Attached is my critique of the Excelaron (Mankins) Draft EIR from San Luis Obispo County (DRC 2009-00002; ED09-039).

# Critique of Excelaron (Mankins) Project Public Draft EIR—

## Hydrology and Geology Sections

Figure 1: Cleath-Harris, 2009, Figure 1, Water Resource Impact Study for the proposed Huasna Oil Field project, Huasna Valley, California following page 2 of that July 21, 2009 study. Scale is not accurate

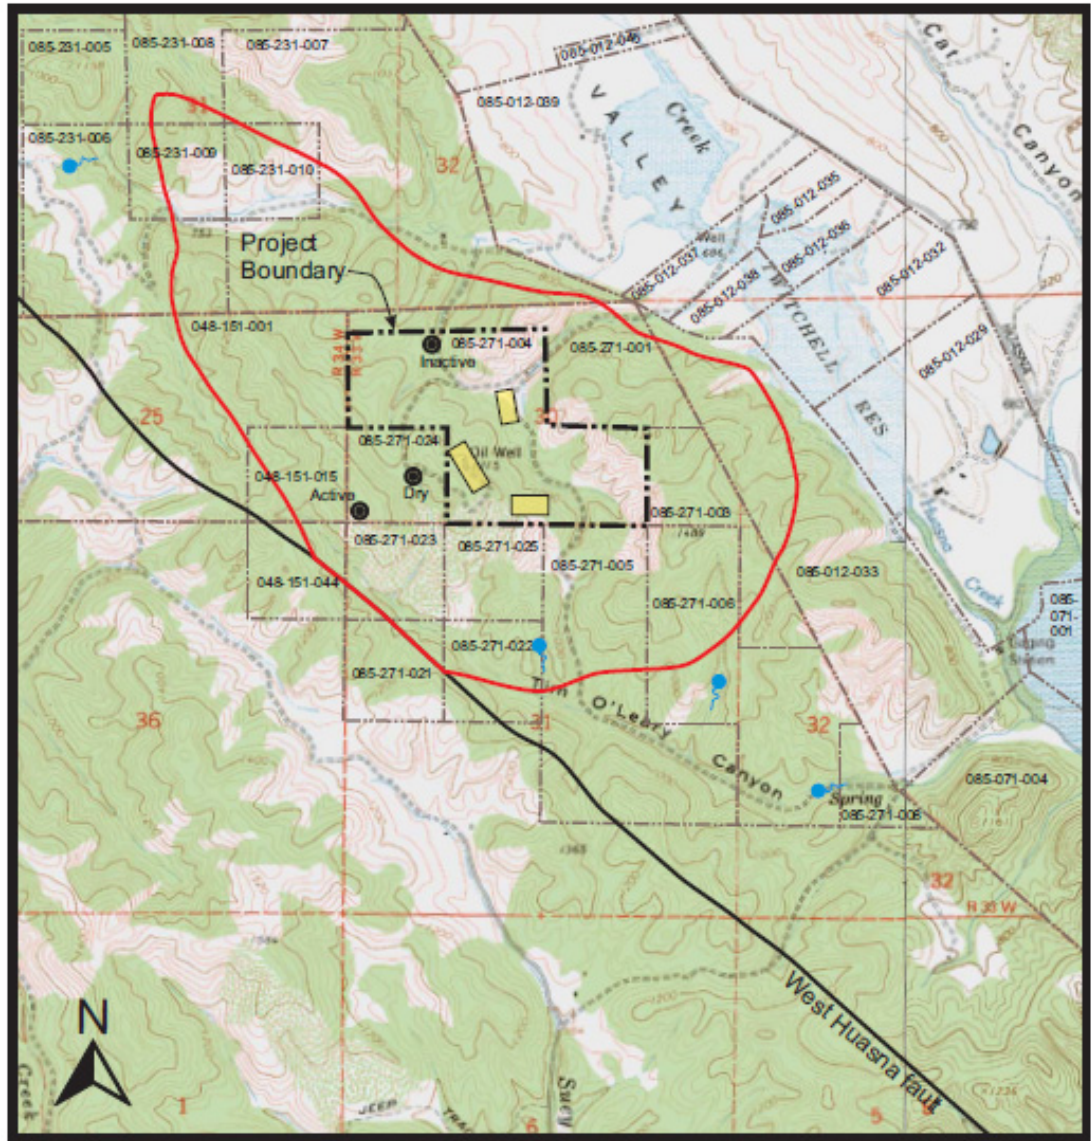
The authors of the Excelaron EIR have attempted to constrain the geographic area of concern for potential water resource impacts to an area of approximately one square mile as shown the Cleath-Harris Geologists' Figure 1 of July 21, 2009 (see figure 1 at end of this report). This map and study are cited in the EIR (Section 4.14) and appear to be the primary reference used by the EIR authors. The report is unpublished but available on the San Luis Obispo County Planning website. An older basic geologic reference paper published in 1967<sup>1</sup> was simplified and interpreted by Cleath-Harris for their July, 2009 submission that became the primary basis for the Water Resource chapter of the EIR.

We cannot determine how Cleath-Harris justified consideration of only the area outlined in their Figure 1. They state that *“Of the parcels shown, seven 40-acre parcels on the southwest side of the project are within the potential impact area and are not owned by Mankins or Porter family members (the proposed project and access to the project are on the Mankins and Porter properties)”* (p. 4 *Excelaron water*). Indeed, further checking confirms that much of the remainder of the Figure 1 area is owned by Mankins or Porter families. But does this exclusion imply that risk of water supply damage is acceptable to all parties? Is it the intention of this exclusion to imply that damage to potable aquifers on Porter and Mankins properties cannot extend beyond their parcel boundaries? Does not the Regional Water Quality Control Board have responsibility for groundwater pollution on both public and private properties under the Porter-Cologne Water Quality Control Act? There is no justification for ignoring potential groundwater contamination over a much wider impact area.

APN 085-271-025 is at 7881 O’Leary Canyon Way immediately south of the southernmost initial exploratory drill pad. APN 085-271-024 is immediately west of the westernmost proposed drill pad at 7222 Cougar Ridge Road (see Cleath-Harris *Excelaron water*, Figure 1). While these are logical and important sites to monitor, they are not sufficient in number, may not be of adequate depth, and may interfere with domestic water uses on those adjacent parcels. If landowners are unsure if they want their wells sampled quarterly, it may be necessary for Excelaron to drill additional water wells for monitoring purposes only. San Luis Obispo County does have access to required well-driller’s records and shares responsibility with the Regional Water Quality Control Board to insure continuing potability of domestic wells. The County could evaluate its well-records while maintaining confidentiality and could therefore assess suitability of private wells to be indicators of regional groundwater contamination.

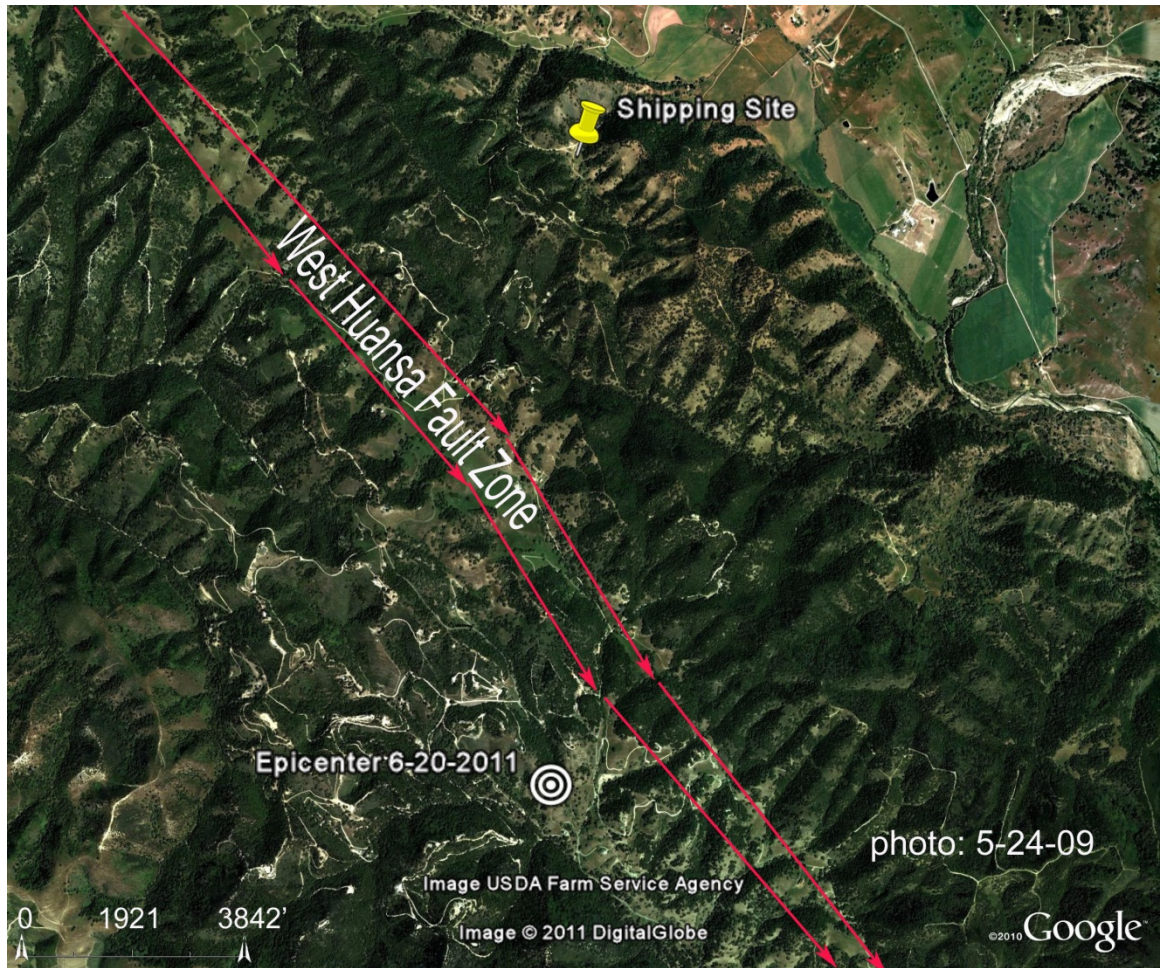
**Induced Seismicity** is a very real hazard associated injection wells. Figure 2 (at the end of this report) is an aerial photo upon which the approximate location of the recent June 20, 2011 earthquake is plotted as is the proposed injection well at the Shipping Site. Injection wells are known to trigger earthquakes by changing the pressure, lubrication, and thermal properties of stressed subsurface rocks. In this case, the focal depth of the recent earthquake was very shallow, less than 4000 feet, and at the primary zone where both production and injection may most likely occur.

Seismic activity is not necessarily damaging. The June magnitude 2.7 and subsequent July 1 M1.1 aftershock along the west Huasna fault zone about 1 mile from the proposed Excelaron project site may have been simply the result a wetter-than-normal winter rainfall volume that loaded the shallow fault zone by recharging the shallow groundwater zone. Similarly, waste water injection may help relieve accumulated stress in the fault zone and adjacent anticline. But this proposed reactivated oil field is now in a rural residential area and proposed activities may induce liability for property damage as well as small earthquakes.
